**Amendment #5**

<b>Title-Sujet</b>		<b>Date</b>	
<b>Lock 26 Concrete Repair</b>		<b>3 October, 2016</b>	
<b>Solicitation No. - No. de l'invitation</b> <b>5P300-16-5268</b>		<b>Client Ref. No. - No. de réf du client.</b>	
<b>GETS Reference No. - No de reference de SEAG</b>			
<b>Solicitation Closes</b> <b>L'invitation prend fin -</b>		<b>Time Zone</b> <b>Fuseau horaire -</b>	
<b>at - à 02:00 PM</b>		<b>Eastern Daylight Time</b>	
<b>on - le 2016-10-05</b>		<b>(EDT)</b>	
<b>F.O.B. - F.A.B.</b>			
<b>Plant-Usine: <input type="checkbox"/> Destination: <input checked="" type="checkbox"/> Other-Autre: <input type="checkbox"/></b>			
<b>Address Inquiries to: - Adresser toute demande de renseignements à :</b>			
<b>Patrick Sullivan at Patrick.Sullivan@pc.gc.ca</b>			
<b>Telephone No. - No de téléphone</b>		<b>Fax No. - No de FAX:</b>	
<b>(819) 420-9557</b>			
<b>Destination of Goods, Services, and Construction:</b> <b>Destinations des biens, services et construction:</b>

## AMENDMENT #5

### **THE PURPOSE OF THIS AMENDMENT IS TO POST QUESTIONS ANSWERS**

### Representative Photos of Existing Gate Control Mechanisms

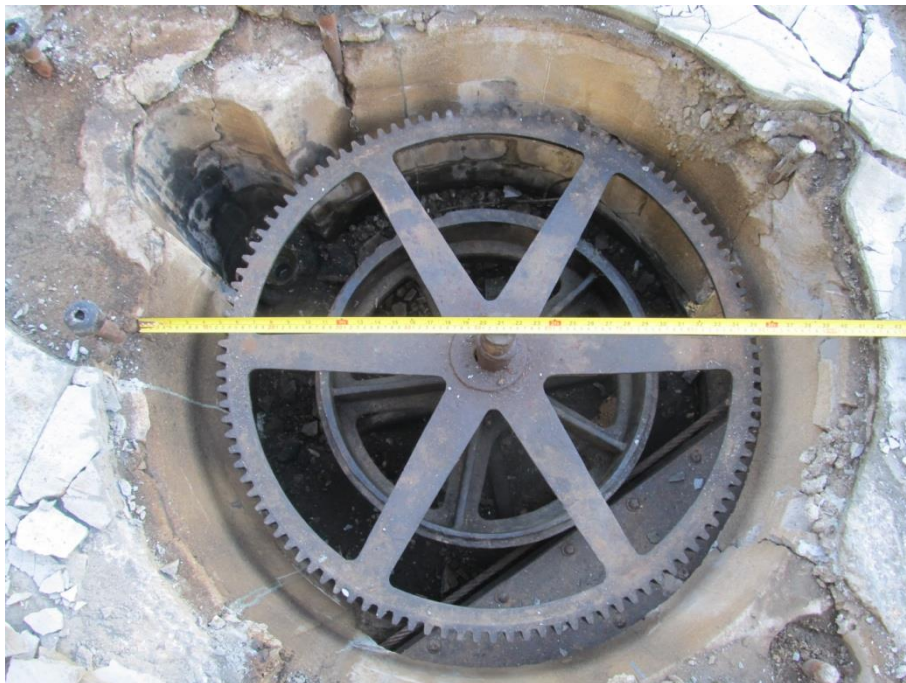
Please provide details of the Gate Controls to be removed, salvaged & reinstalled.

Question 8: Please provide details of the Roller Bar and Attachments to be removed, salvaged & reinstalled

The only information available for the gate controls to be removed, salvaged & reinstalled is a selection of existing conditions photographs. Representative photos are included in this addendum.

The only information available for the Roller Bar and Attachments to be removed, salvaged & reinstalled is a selection of existing conditions photographs. Representative photos showing the wall mounted Roller Bars at Lock 26 are included in this addendum.
